REQUEST FOR COUNCIL ACTION

AGENDA SECTION: PUBLIC HEARINGS	ORIGINATING DEPT: PLANNING	ITEM NO. E-11
ITEM DESCRIPTION: Final Plat #02-21 to be known as Stonebridge		PREPARED BY: Brent Svenby, Planner

RE: Final Plat #02-21 to be known as Stonebridge.

STONEBRIDGE

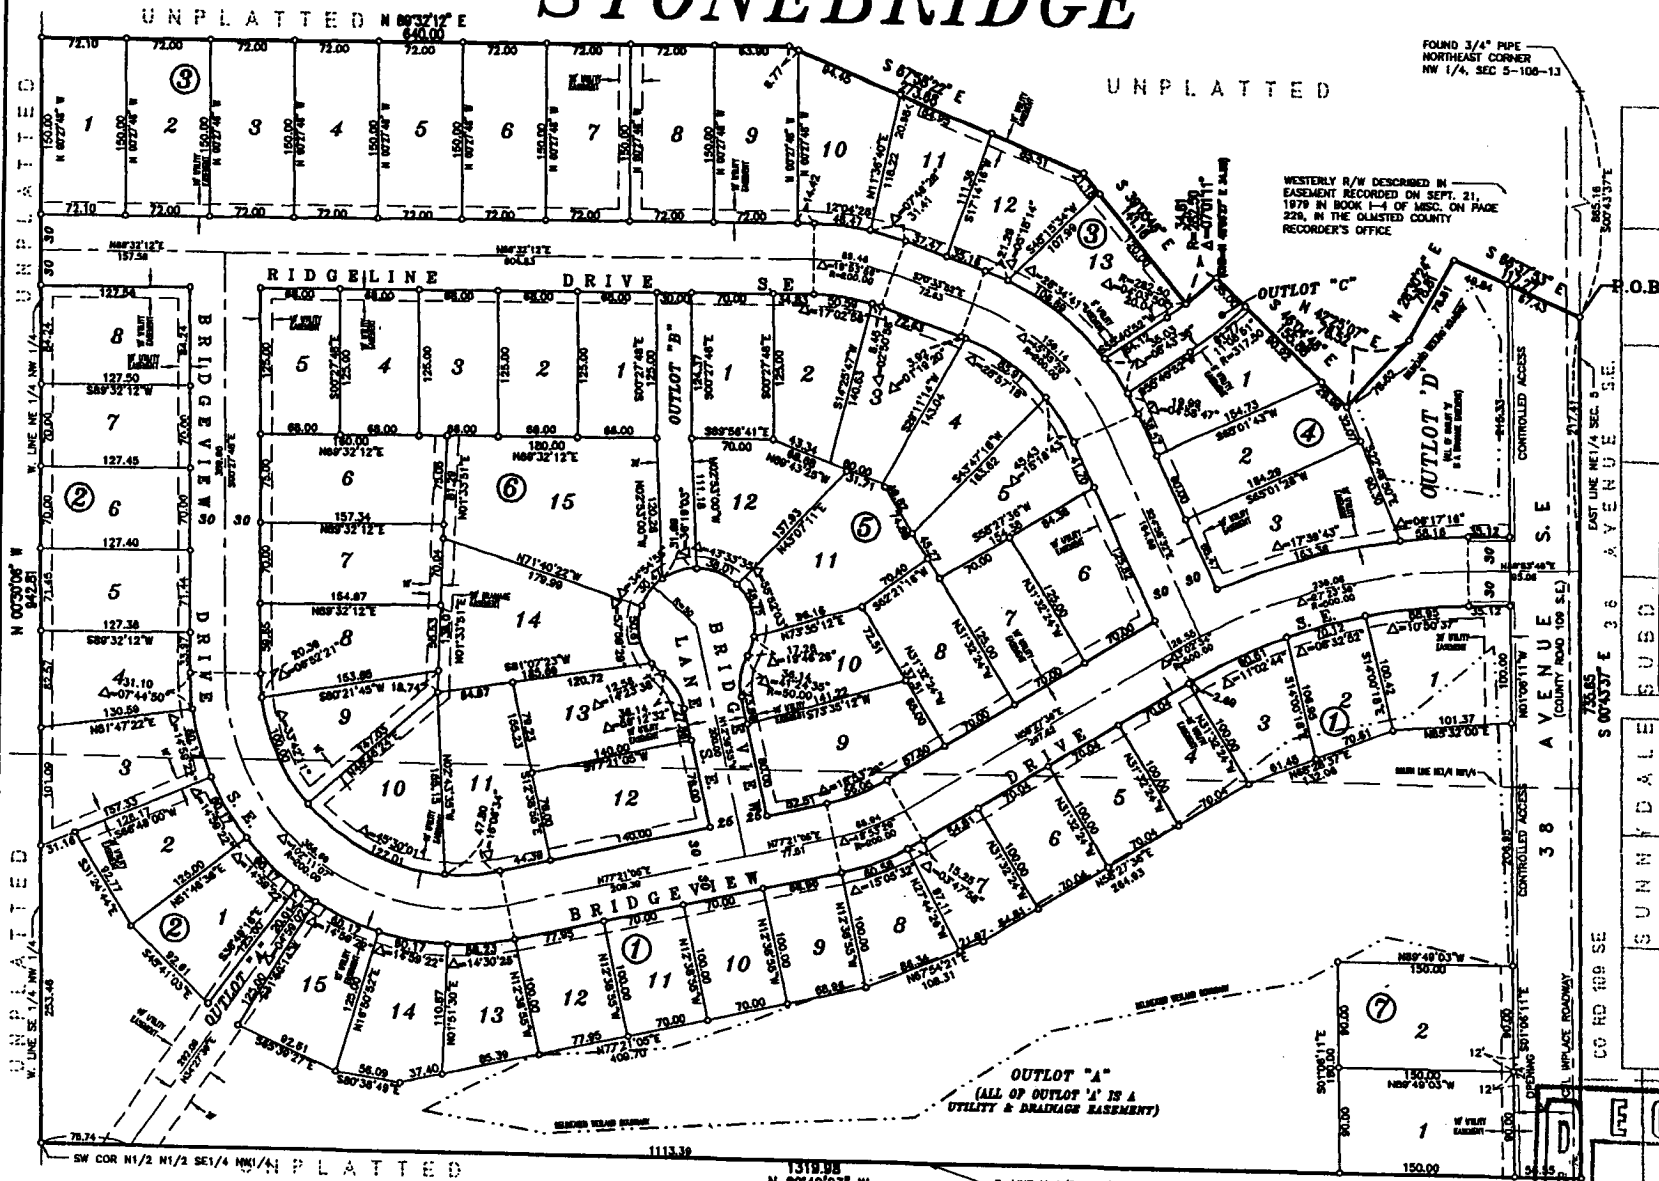
- 4. Outlot B shall be dedicated to the City Rochester after the mid-block pedestrian connection is constructed.*
- 5. The final plat documents shall be revised to dedicate a 10 foot drainage easement along the south side of Lot 11, Block 5 and along the north side of Lots 8 and 10, Block 5 as shown on the grading plan.*

- 6. The final plat documents shall be revised changing the roadway designation from 38 Avenue SE (County Road 109) to 36 Avenue SE (County Road 109).*

- 7. No Parking shall be allowed and "No Parking" signs shall be posted along one side of Bridgeview Lane SE.*

1. The roadway on this plat illustrated as 38 AVENUE SE (COUNTY ROAD 109 SE) is still wrong and needs to be corrected.

RECOMMENDATION: Change roadway designation to read 36 AVENUE SE (COUNTY ROAD 109).
